RE: Mitac Technology Corp.

FCC ID: MAU031

Image 1

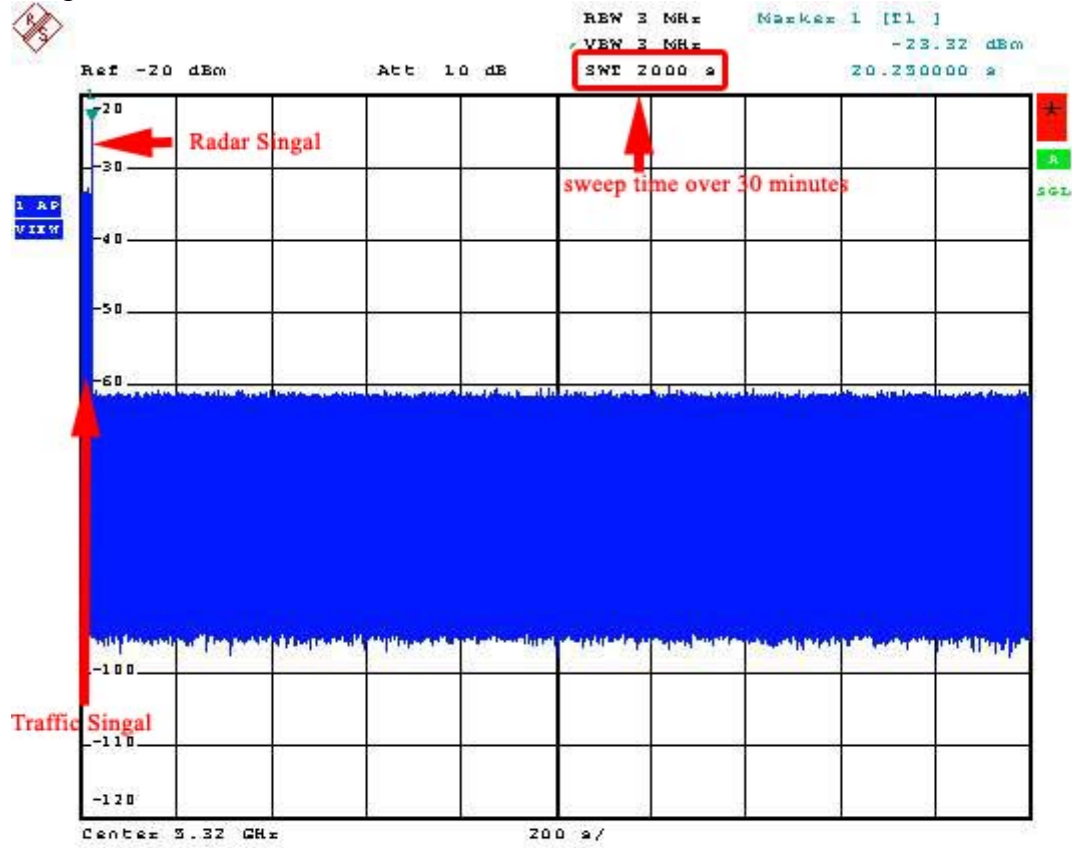
15) FCC has recently been asking for the following additional test: Client devices - Test client devices to ensure that they comply with the 30 minute non-occupancy requirement for a channel after moving off of a channel when radar is detected. Some clients will send beacons on a channel that is supposed to be cleared for 30 minutes. This non-occupancy test was not required in the original test procedure as published. FCC is requiring the test to be conducted effectively immediately (August 14, 2007 TCB Conference Call). TCBs must check for this requirement before grant. This test does not appear to be performed.

Ans: We take a image capture from spectrum for sweep time 2000 seconds (Image 1) to monitor the connection . The device was comply with the 30 minute non-occupancy requirement for a channel after moving off of a channel when radar is detected. And we prepare the other image capture from web form of the support access point (Cisco 1240AG) for your reference.
